APPLICATION NO.	FILING DATE	FIRST NAMED INVENTOR	ATTORNEY DOCKET NO.	CONFIRMATION NO.
10/633,288	08/01/2003	Charles L. Branch	MSDI-261/PC750.00	3338
52196 7590 01/09/2009 KRIEG DEVAULT LLP ONE INDIANA SQUARE, SUITE 2800 INDIANAPOLIS, IN 46204-2709				
EXAMINER				
RAMANA, ANURADHA				
ART UNIT		PAPER NUMBER		
3775				
MAIL DATE		DELIVERY MODE		
01/09/2009		PAPER

Office Action Summary

DETAILED ACTION

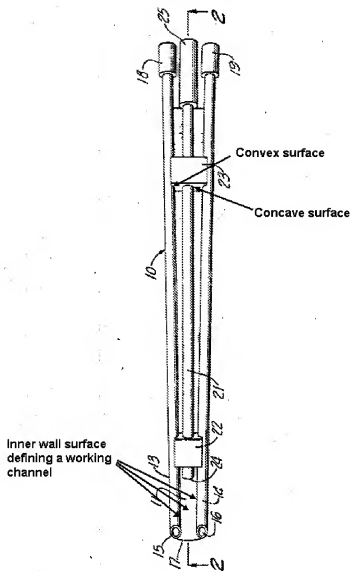
Florin discloses a retractor with an inner wall surface defining a working channel therealong and a fiber optic element or lighting element 21 with resilient or bendable wall members (22, 23) engageable with the inner wall surface (Figs. 1, 2, col. 1, lines 21-47 and col. 2, lines 1-23). Each wall member extends along the width of the inner wall surface (Figs. 2 and 3). Further, each wall member has a convexly curved surface and a concavely curved wall surface opposite the convexly curved surface.

Applicant's arguments with respect to the rejections over Florin are not persuasive because, the clips or wall members (22, 23) are inherently resilient, otherwise, they would not work for their intended purpose, namely holding the lighting element, in position, on an inner wall surface of the retractor. Marked up Fig. 1 from Florin is provided on the following page, to clarify the examiner's interpretation of Florin.
